DOCUMENT CHANGE REQUEST

DCR number 593	Changes required for: General	Originator: Jean-Laurent BOUTEAUX
Date: 2010/04/21	Date sent: 2010/04/21	Organisation: CNES
Status: IMPLEMENTED

Title:	Connectors Miniature Electrical Circular Triple-Start Self-Locking Coupling Scoop-Proof Hermetic		
Number:	3401/057	Issue:	2

25-24
12#16 & 12#16

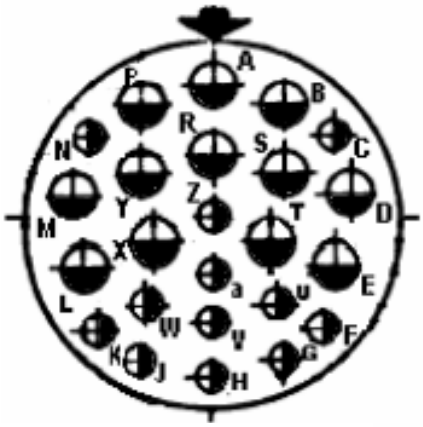
Page 13 "Special contact arrangements"
Add 25-24 (12 #16 & 12 #12)
Page 19 Â§ 4.5.4.3 Contact arrangements
Add 25-24 Service Rating II

Extension of the contact arrangements range available further a customer request.
Contacts size 16 are already qualified in arrangements 17-08 and 19-11, contacts size 12 in the arrangement 25-24.In the next maintenance of qualification, there will be samples with 25-24 arrangement.

Attachments:
3401_057_DCR_04_2010pdf.pdf, null
Modifications:
The attachment (page 13) to be corrected: 25-24 arrangement It should read: 25-24 12 #12 & 12 #16
Approval signature:
